July 3, 2017  
File: 21081375

Reference: **Peer Review – Stormwater Management and Erosion Control  
Belmont Day School Barn and Entry Drive  
Belmont, Massachusetts**

On behalf of the Belmont Day School, we submit this letter with response to the to the comments contained in the letter prepared by BSC Group to your office dated June 28, 2017. Original comments issued by the BSC Group are shown in italic and responses from Stantec are noted below each comment.

**L3.01**

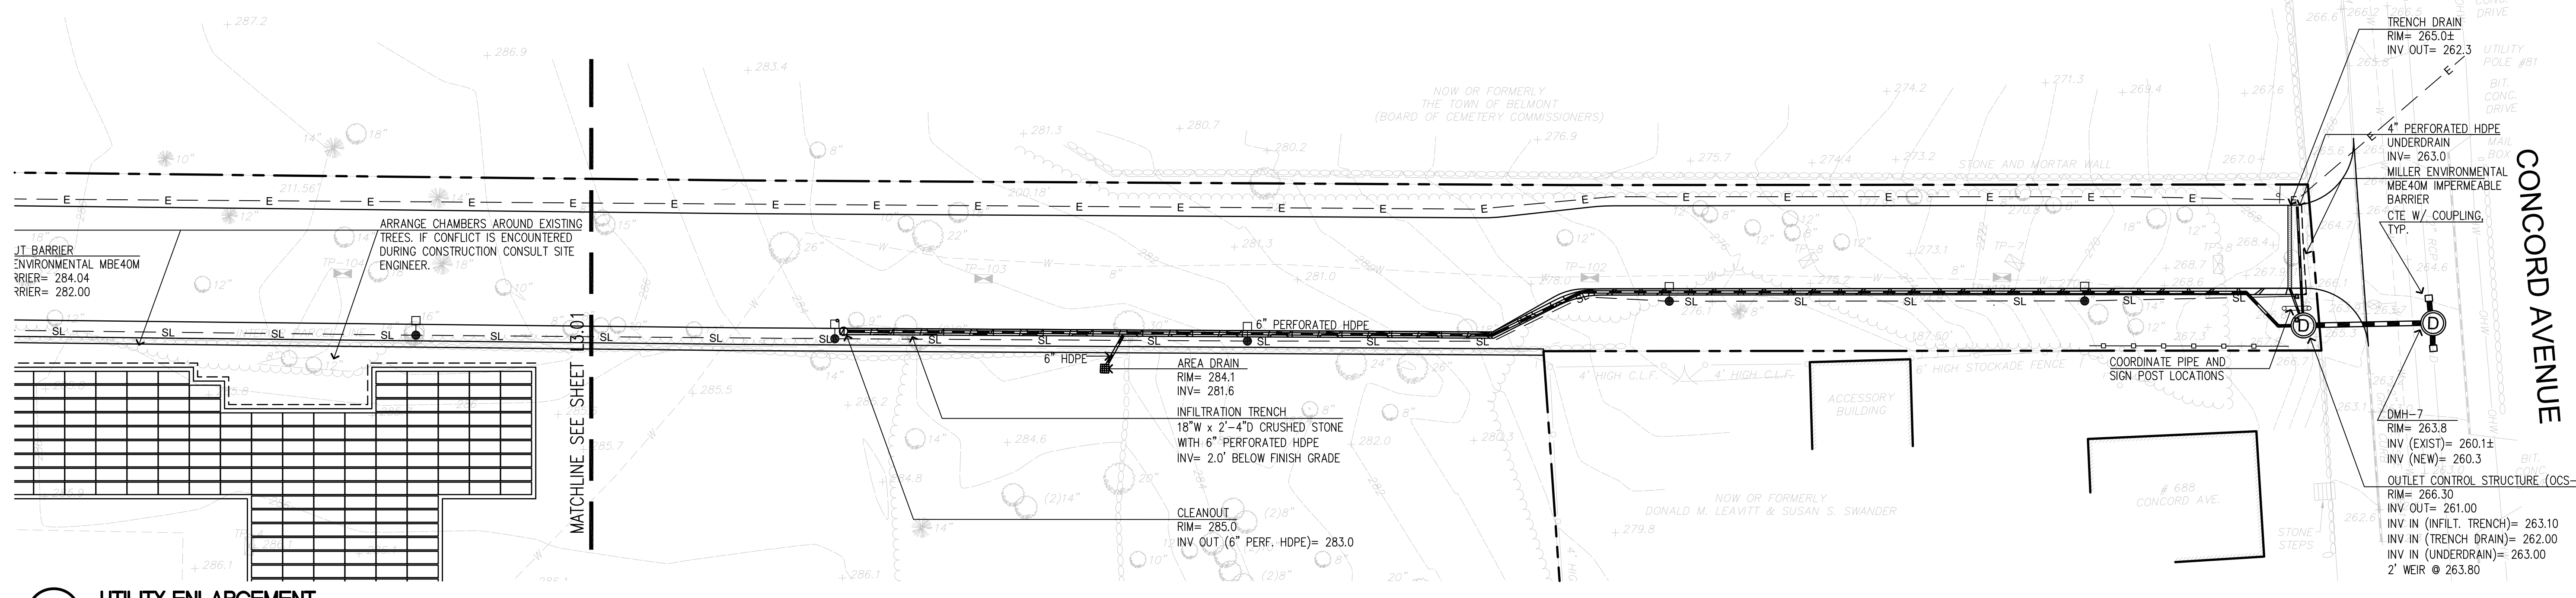
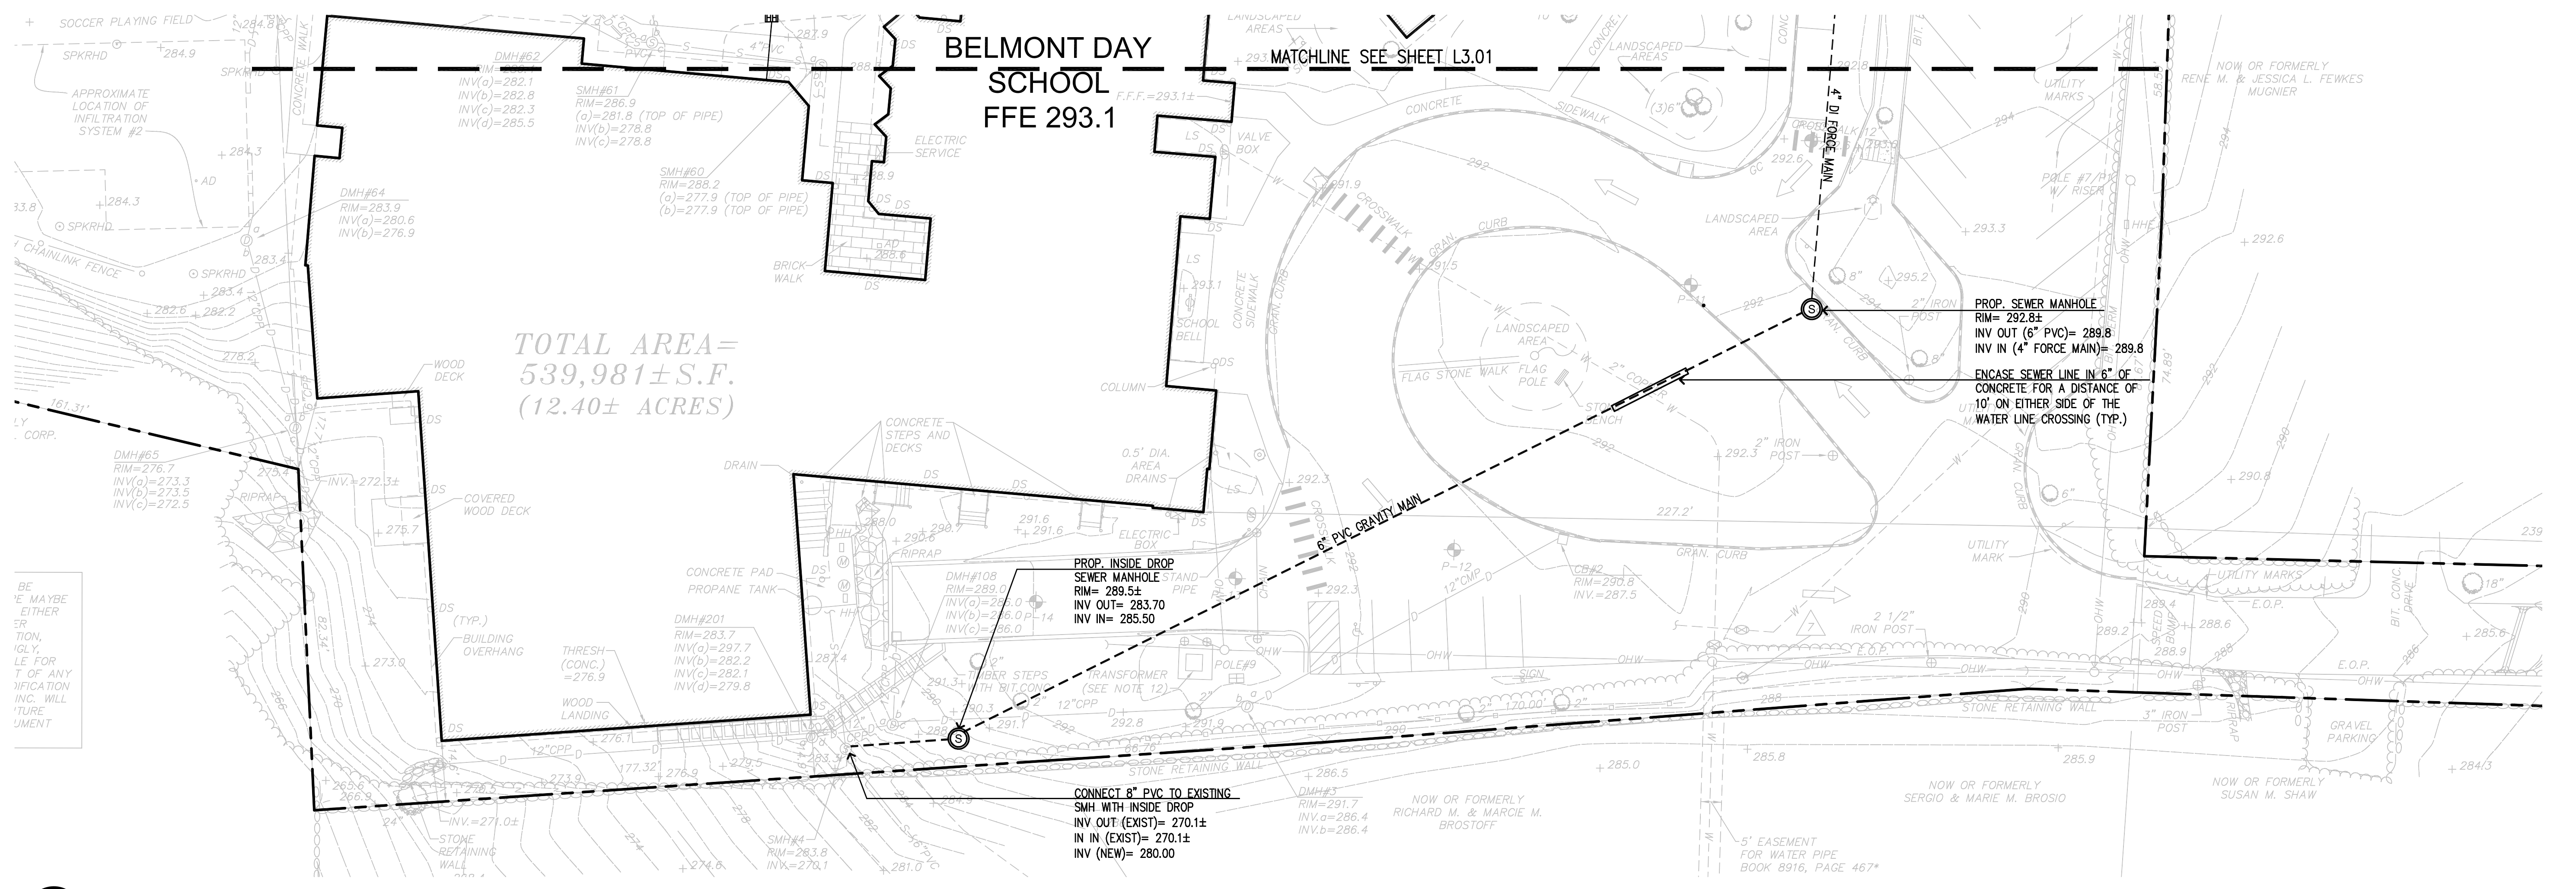
6. **Comment:** *As both the proposed underground infiltration system and porous asphalt pavement will be located close to existing and new trees, we recommend that a vertical root barrier be installed between the trees and the new systems to prevent root intrusion.*

7. **Comment:** *We recommend the use of a manifold system at the outlet of the underground infiltration system. A manifold system will allow for better flow out of the system and help prevent the system from backing up in larger storm events.*

11. **Comment:** *The Utility Plan (Sheet L3.02) calls for an “impermeable barrier” at the end of the porous asphalt driveway where it meets Concord Avenue. However, the Porous Asphalt Pavement detail (sheet L5.01) calls for a geotextile fabric at the end of the driveway. We recommend that a truly impermeable barrier similar to the proposed check dams be placed at the end of the driveway.*

**Response:** Acknowledged. We have added a vertical root barrier to the Utility Plan (Drawing L3.01), and the revised plan is attached.

**Response:** Acknowledged. We have added a manifold to the Utility Plan (Drawing L3.01), and the revised plan is attached.

**Response:** Acknowledged. The Utility Plan (Drawing L3.01) and detail 8 included on the Utility Details Plan (Drawing L6.01) have been revised to call for an impermeable barrier at the end of the driveway, at both limits of the porous pavement.

**8 POROUS ASPHALT PAVEMENT**  
NTS

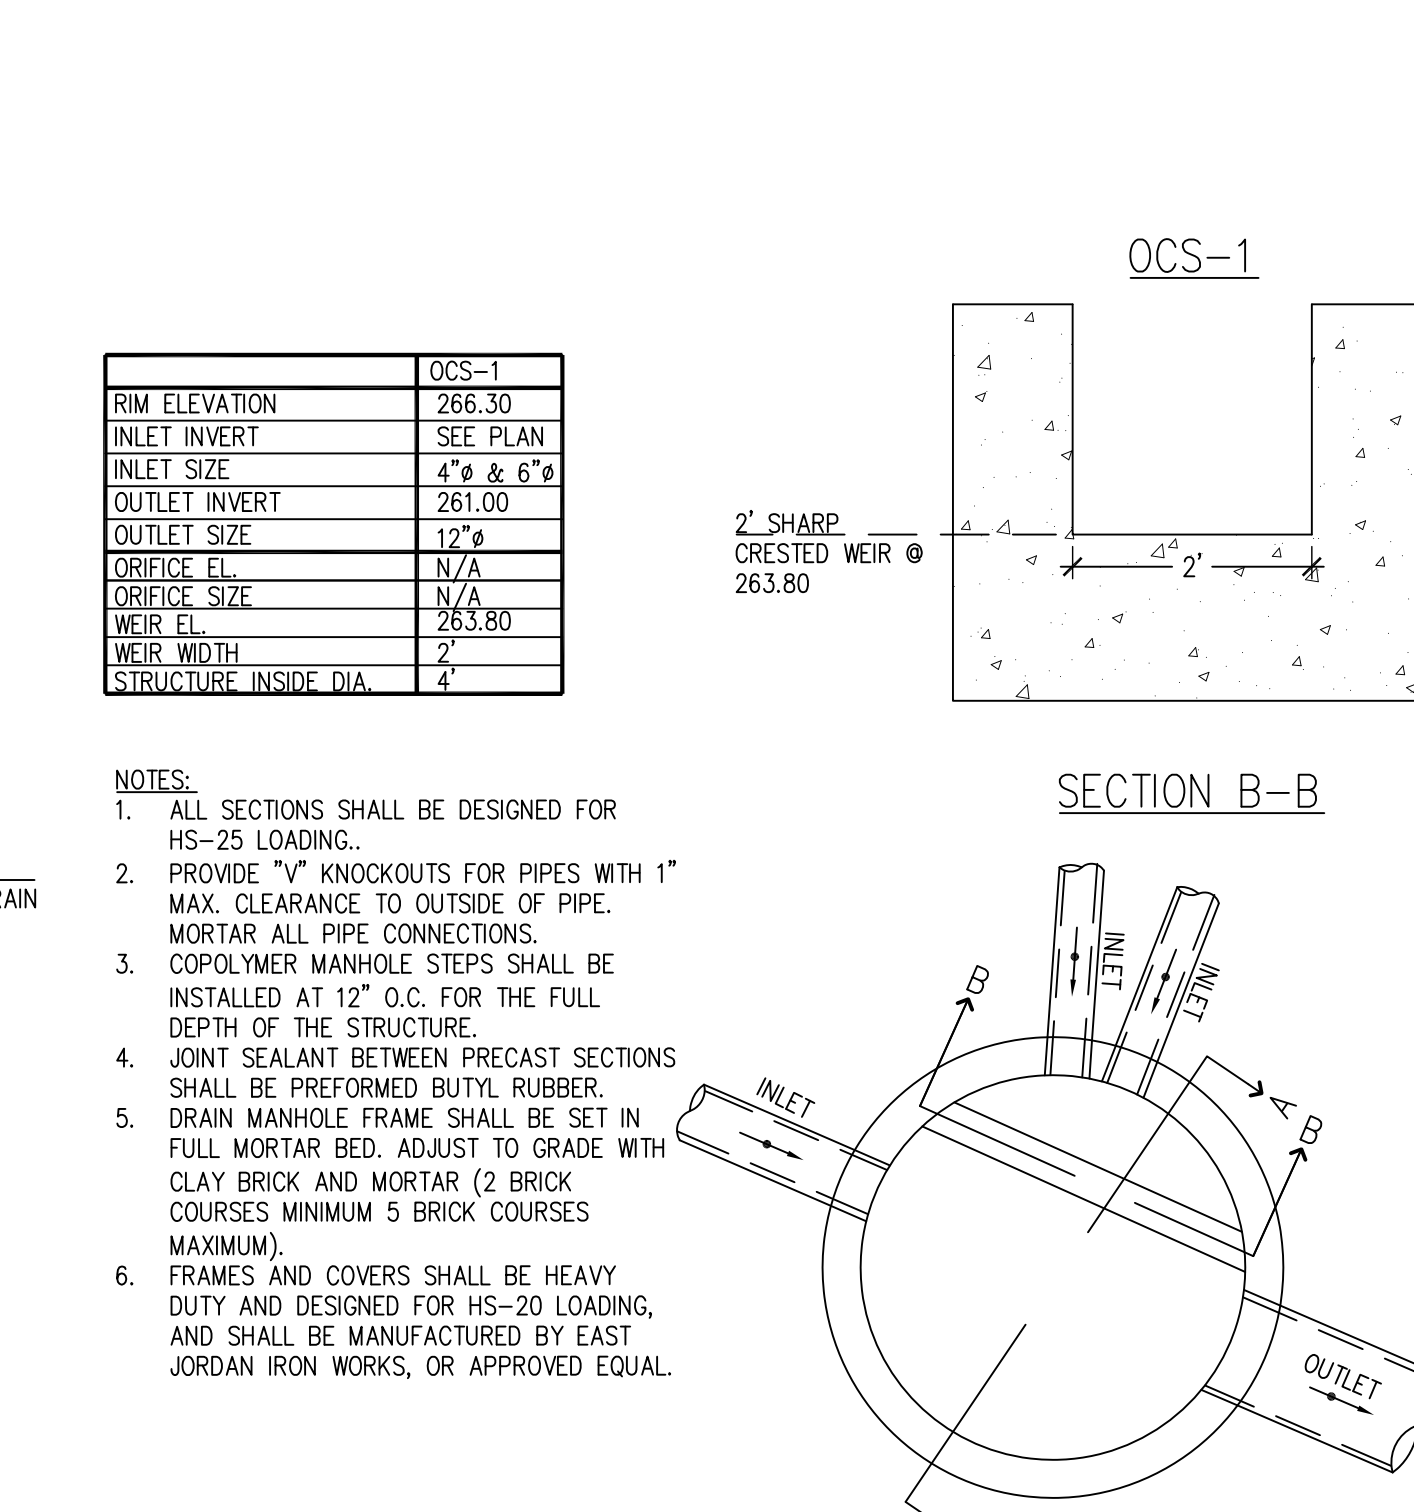
9. **Comment:** *The use of a liner check dam as shown on the Porous Asphalt Pavement detail (Sheet L5.01) is appropriate as the driveway does include areas steeper than 5% grade. However, we recommend that the detail be revised to include the dimensions for these check dams.*

**Response:** Acknowledged. We have added dimensions to detail 8 included on the Utility Details plan (Drawing L6.01) to indicate that the check dams should extend to within 3" of the bottom of pavement.
